Re: Third Submission Review: QuikTrip 4263 – Site Plan & Conditional Use
Application Number: DA-1483-03
Case Numbers: 2000-6044-07; 2000-6044-08

Project Name: Quiktrip at Havana and Parker Road

QUIKTRIP 4263 SITE PLAN AND CONDITIONAL USE

QUIKTRIP 4263
PARKER RD. & HAVANA
SITE PLAN
DETAILED SITE PLAN

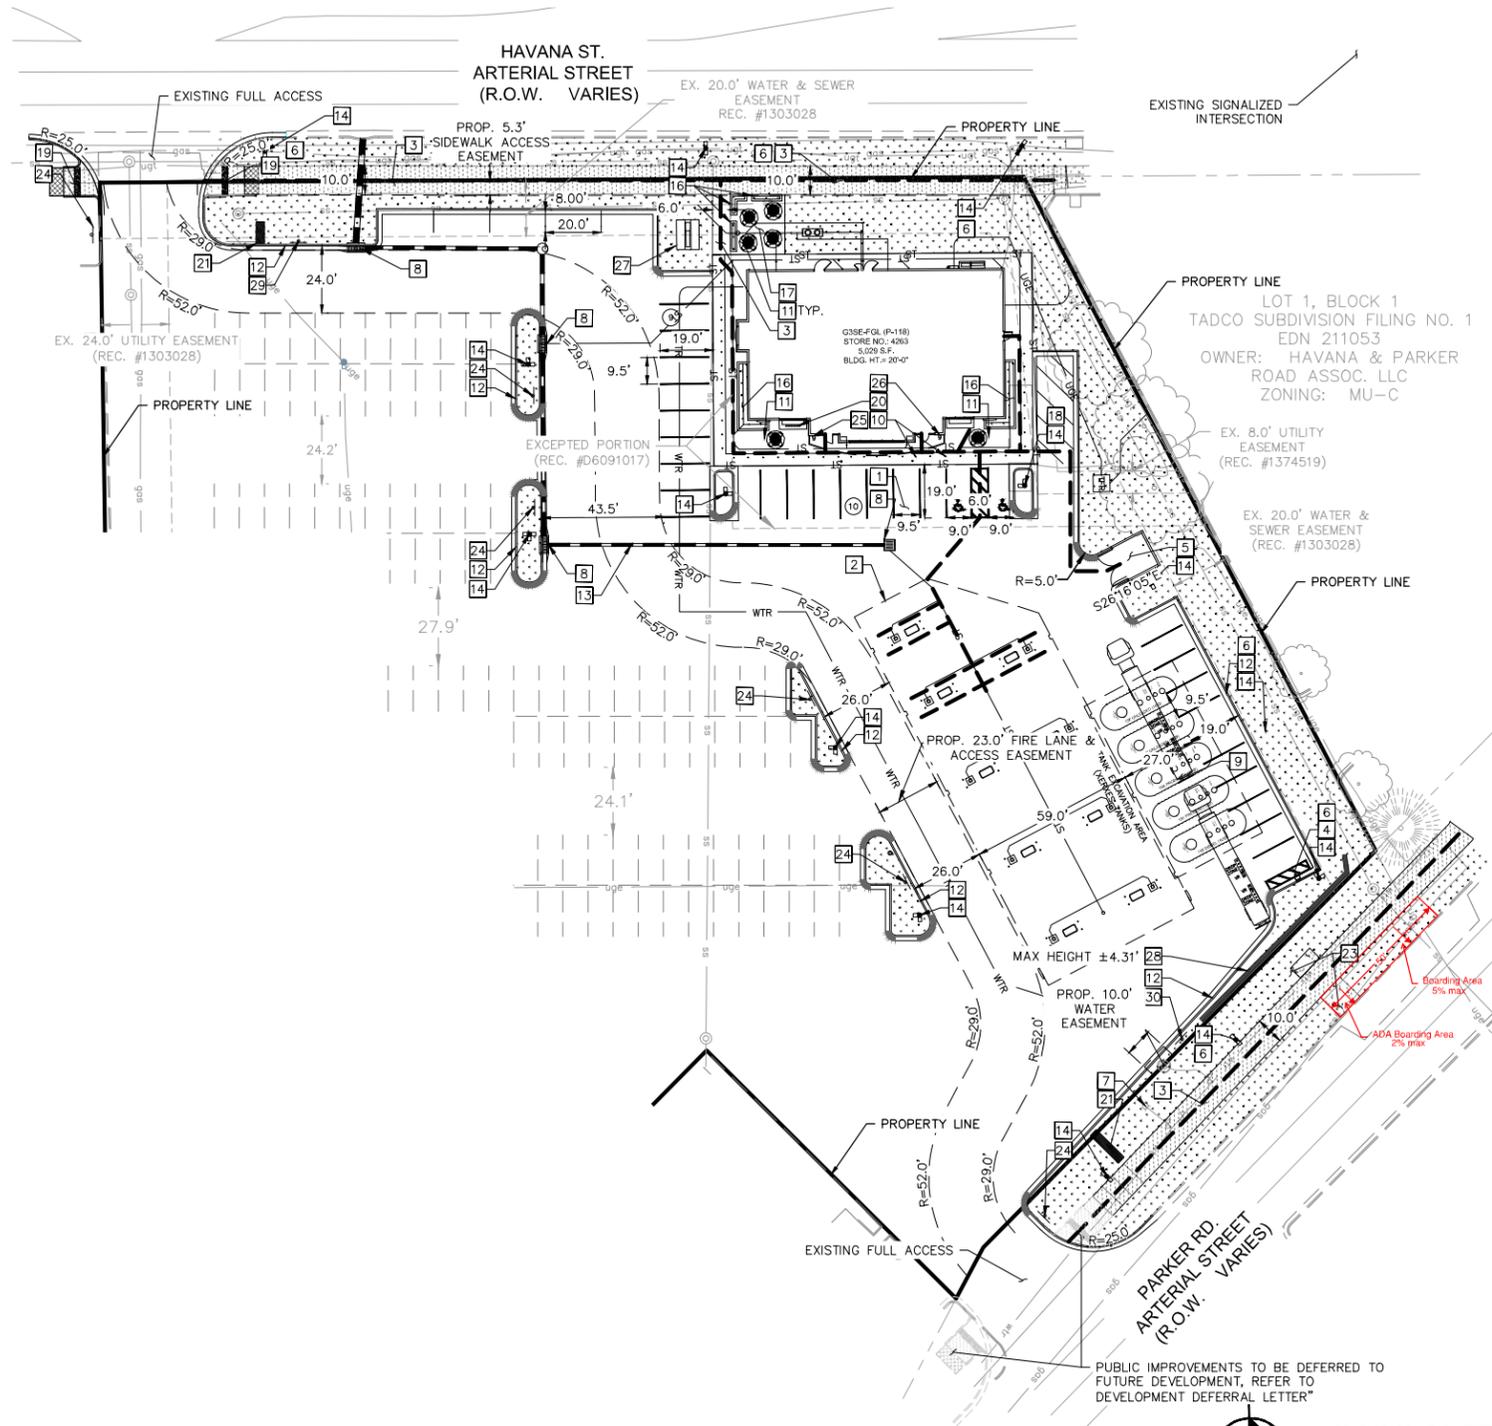
- 4A. (Repeat comment) Please affirm that all parking spaces are 9' by 19'. Some along the east side of the storefront appear 8' wide.

- 6A. This monument sign continues to be off-site. Off-site monument signs are not permitted in this zone district per §146-4.10.13. You will need to consider an alternate location.
